**MONTGOMERY COUNTY PLANNING DEPARTMENT**  
 THE MARYLAND-NATIONAL CAPITAL PARK AND PLANNING COMMISSION

**MEMORANDUM**

REVIEW TYPE: **Preliminary Plan Amendment**  
**Site Plan Amendment**  
 PROJECT NAME: Park Potomac (Formerly Fortune Parc)  
 CASE #: Preliminary Plan Amendment 1-2003029A  
 Site Plan Amendment 8-2004015B  
 APPLYING FOR: Approval to redistribute the non-residential FAR to allow up to an additional 115,000 square feet of restaurant/retail uses to include a grocery store; include a 156-room hotel use within the approved 850,000 GSF of commercial uses; redesign the plaza at Park Potomac Avenue and Cadbury Avenue; revise the design of the streetscape along the retail frontage on the east side of Park Potomac Avenue; modify vehicular access to and from Montrose Road; and reduce the required setback from I-270 for a portion of Building E and the structured parking lot, between stations 541+01.93 and 541+55.95 (a distance of 54.02 feet), from the approved 85 feet to 80 feet for the building and from the approved 35 feet to 28 feet for the parking lot.

Public Plaza Illustrative Plan

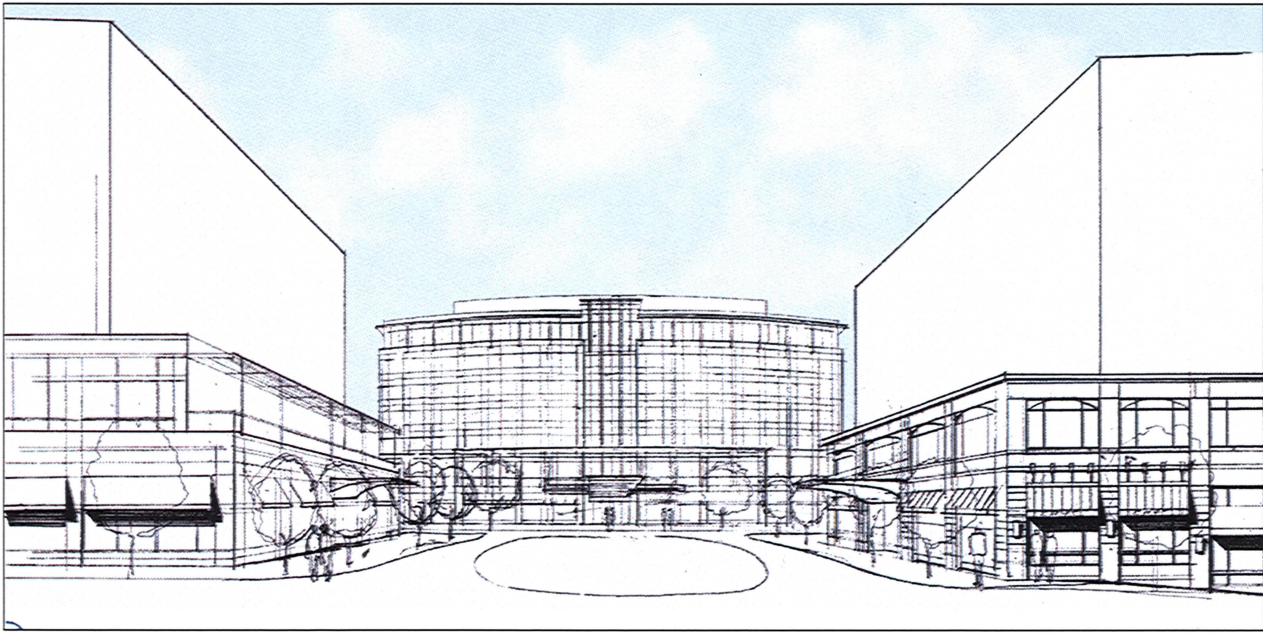
For the larger community's primary public space, the Applicant is proposing a public plaza at the intersection of Park Potomac Avenue and Cadbury Avenue. The space, which is approximately 27,000 square feet (0.62 acres), is bound on the north and south by the Hotel Building F and the office/restaurant/retail Building D, and to the east and west by office/restaurant/retail Building E and Park Potomac Avenue. The plaza is designed to serve both as a single large public space that can be closed off to automobiles for events and as a variety of constituent spaces that can be used separately. Individual spaces include generous sidewalks for outdoor seating for restaurants or retail shops as well as a central "island" with unique treatments including a fire pit, a fountain, and shaded seating areas. Additionally, the space provides vehicular access to the parking lots on the east side of the site as well as a pick-up and drop-off area for the hotel and retail.

Staff worked with the Applicant's team to ensure that, despite shared accommodation for vehicle and pedestrian, the design would treat the space as a single, primarily pedestrian, space. There were two parts to this solution: horizontal and vertical. On the ground plane, the Applicant's design uses a complimentary paving palette and low planters to visually unify the "sidewalk" areas in front of each

building with the central plaza design. To provide vertical definition and enclosure of the plaza, the Applicant's building massing proposes a horizontal datum of two full stories, or 35 feet, on each built side of the plaza. Similar projects that successfully create public space, like Bethesda Row and Reston Town Center, provide about 35-40 feet of base for spaces 90-100 feet wide. Downtown Silver Spring provides 35-50 feet for a space about 140 feet wide. The Park Potomac plaza is about 130 feet wide. While this datum encloses the space as a whole, the Applicant has also agreed to provide pedestrian-scaled elements at the ground floor level, such as awnings or similar projections, to help activate the restaurant and retail frontage.

2. Along the portions of Buildings D, E, and F fronting the plaza, the Applicant will provide pedestrian-scaled projecting elements at the ground floor, such as awnings or similar embellishments, to help activate the restaurant and retail frontage.

Streetscape Option 1: Steps in the Right of Way

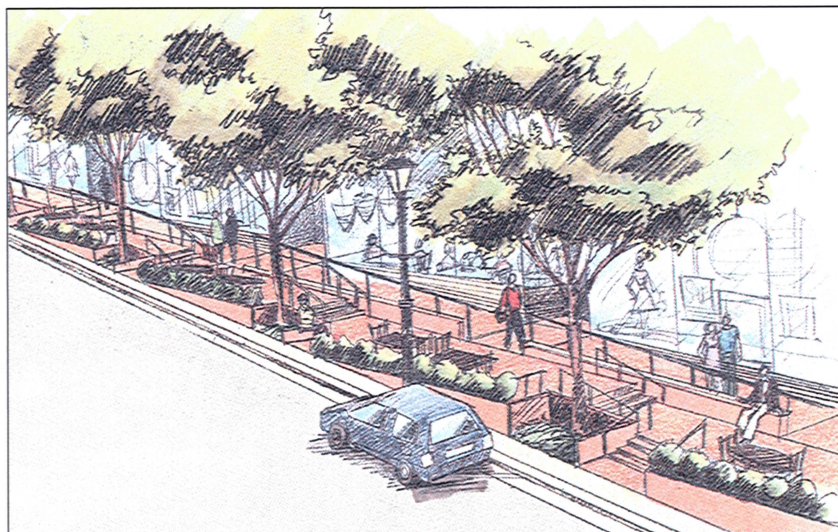
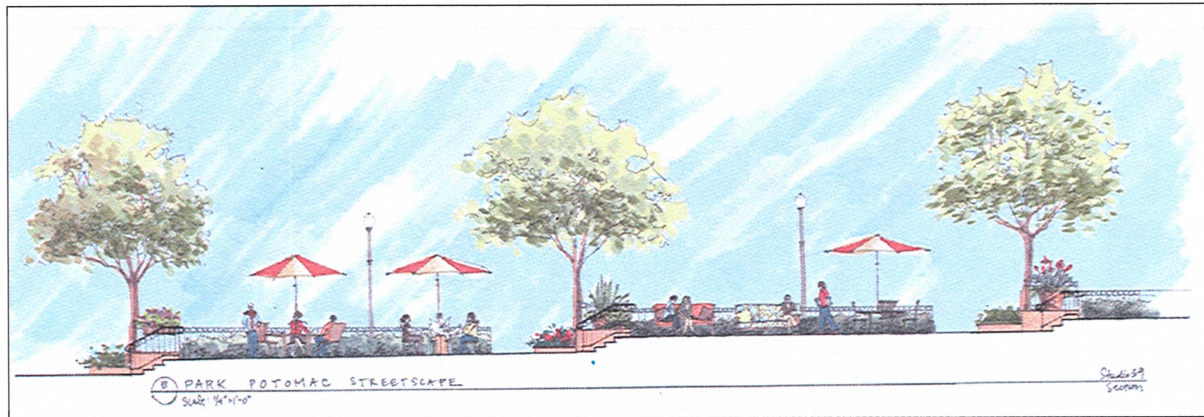
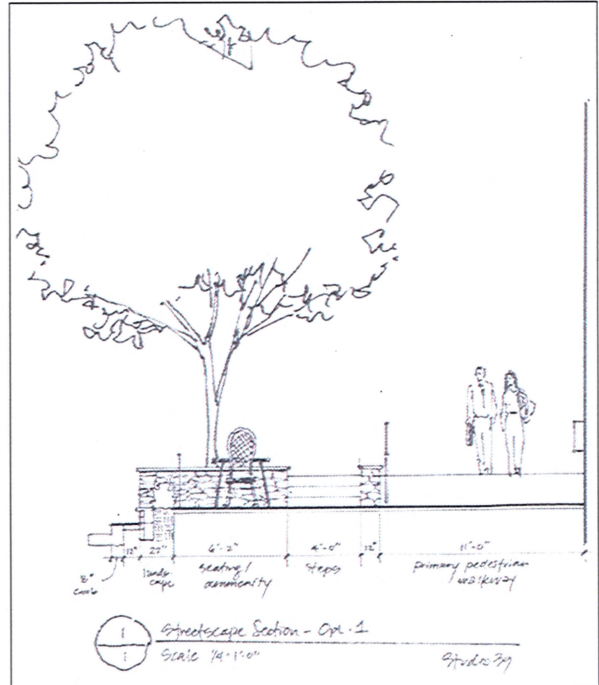
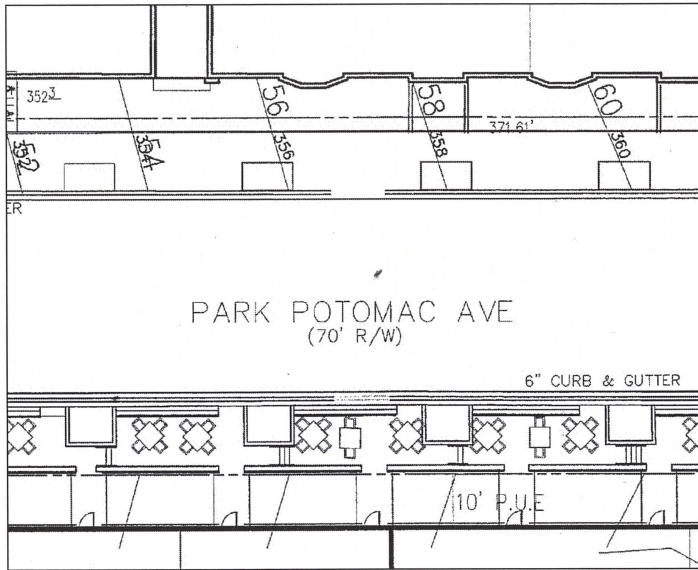
In order to help activate the retail sidewalk for Buildings C and D on the east side of Park Potomac Avenue, between the transit facility and the plaza the Applicant is proposing an innovative streetscape design (see Attachment B). This block of the Avenue takes up a significant amount of grade, approximately 27 vertical feet. To provide accessible retail frontage, the sidewalk directly in front of the building is comprised of a series of landings joined by a 10-foot-wide accessible ramp. These landings are intended to correspond with the retail entries along this block, and will extend toward Park Potomac Avenue to corresponding terraces along the street edge. These terraces may be used for outdoor restaurant seating, a shaded place to sit, or similar activity. A low wall will separate the ramps from the terraces. Between the terraces and the street, low retaining walls or planters will transition to an extended curb, facilitating access from the on-street parking into the retail area.

Engineering and Operations Section would like to hear the Planning Board's preferred design alternative before completing their review of the Design Exceptions package. Staff prefers Option 2, believing that there will not be enough pedestrian traffic along this street to warrant a path at both the retail edge and the street edge and that the larger seating areas will be better used by a respite-seeking public. In either case, staff prefers either of the proposed options to the third option of approving neither streetscape alternative, in which case the streetscape design included in the amended Site Plan would remain in effect. That design is a standard DPWT configuration, similar to that across Park Potomac Avenue.

3. The Applicant will revise the streetscape design along the Park Potomac Avenue frontage of Buildings C and D per the Planning Board’s recommended Streetscape Option [to be determined], subject to DPWT approval. The Applicant understands that failure to obtain DPWT approval for the recommended streetscape alternative will require the Applicant to amend the Site Plan accordingly..
